VOGTLE ELECTRIC GENERATING PLANT
CORRECTION TO INSERVICE INSPECTION SUMMARY REPORT
FOR
VEGP-1 FALL 1991 MAINTENANCE/REFUELING OUTAGE
INSTRUCTIONS FOR INCORPORATION

The corrected pages to Volume 1 of the VEGP-1 ISI Final Report for the Fall 1991 maintenance/refueling outage would be incorporated as follows:

* Insert drawings ISI-11201-009 through -012 after drawing ISI-11201-008.

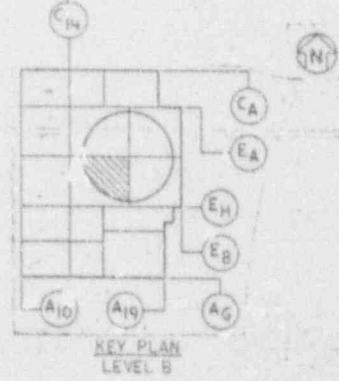
REVISION	DATE	REVISION	DATE	REVISION	DATE
					8-11-92
DELETED LINE 11201-021 PER DCP 91-V-12009 ADDED 2" THERMOWELL (WELD 10) ADDED NEW REF DRAWING					
BY	CHKD	APPR.1	APPR.2	APPR.3	APPR.4
BY	CHKD	APPR.1	APPR.2	APPR.3	APPR.4

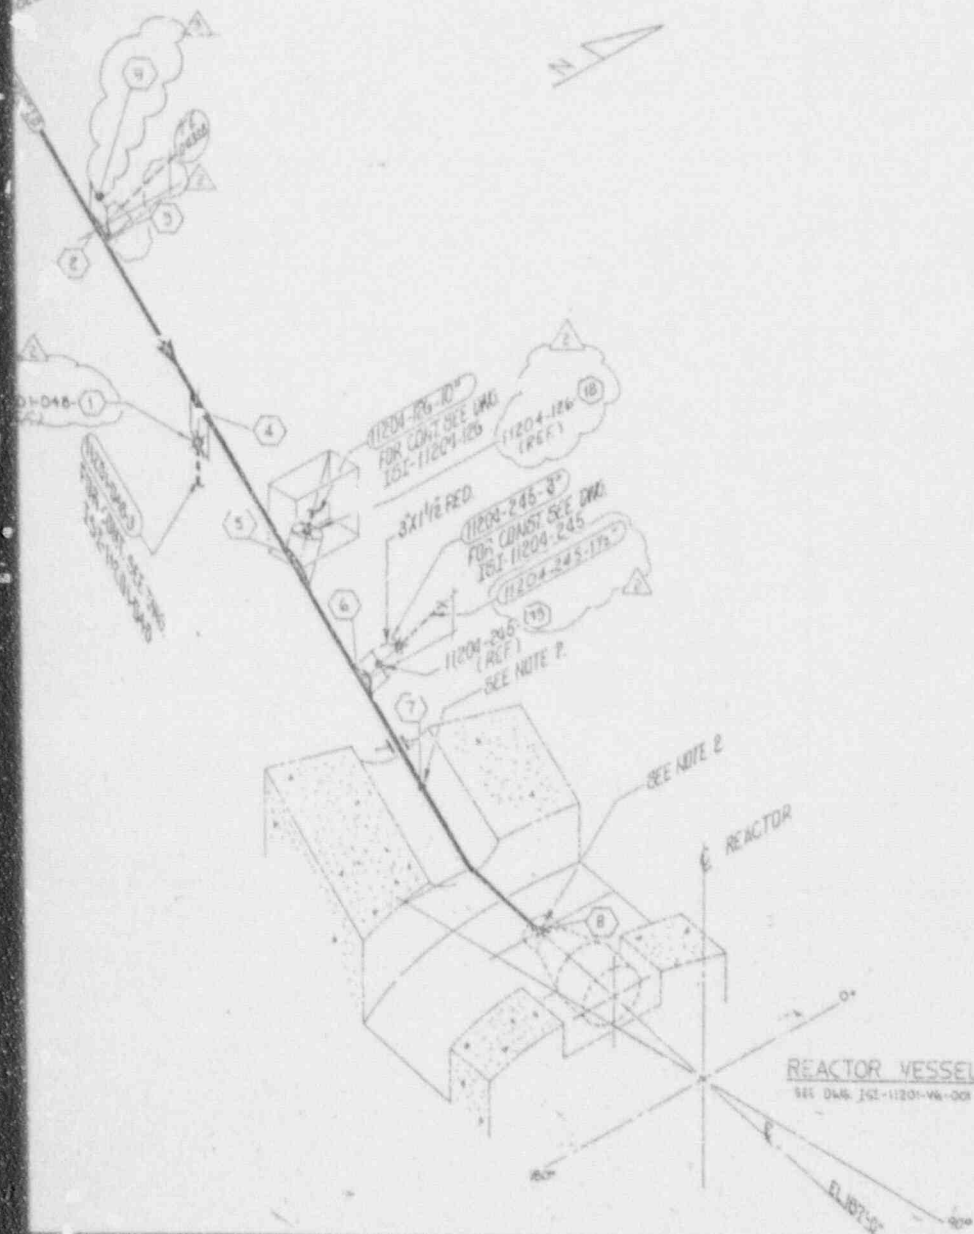
REVISION	DATE	REVISION	DATE	REVISION	DATE
					8-11-97
DELETED LINE 11201-27 PER DCP 91-VI00009 ADDED 2" THERMOWELL (WELD 9) ADDED NEW REF DRAWING					
BY	DATE	APPROV. 1	APPROV. 2	APPROV. 3	APPROV. 4

DESIGNED BY	DRW'D BY	BY	1120 W.S.
SCALE	PROJECT NO.	DRAWING NUMBER	REV.
NONE		ISI-11201-009	3

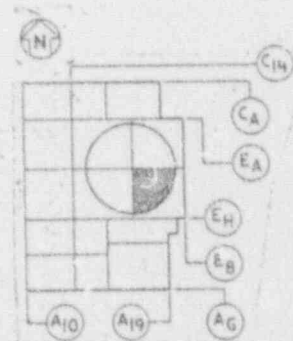
A	REVISION							DATE							REVISION 9							DATE 8-11-92						
															DELETED LINE 11E1-025 REL DCP #1-VI00009 ADDED 2" THERMOWELL (FIELD 10) ADDED NEW REF DRAWING													
	BT	CHK'D	APPR. 1	APPR. 2	APPR. 3	APPR. 4	APPR. 5	BT	CHK'D	APPR. 1	APPR. 2	APPR. 3	APPR. 4	APPR. 5	BT	CHK'D	APPR. 1	APPR. 2	APPR. 3	APPR. 4	APPR. 5							
																GS	DR	DR
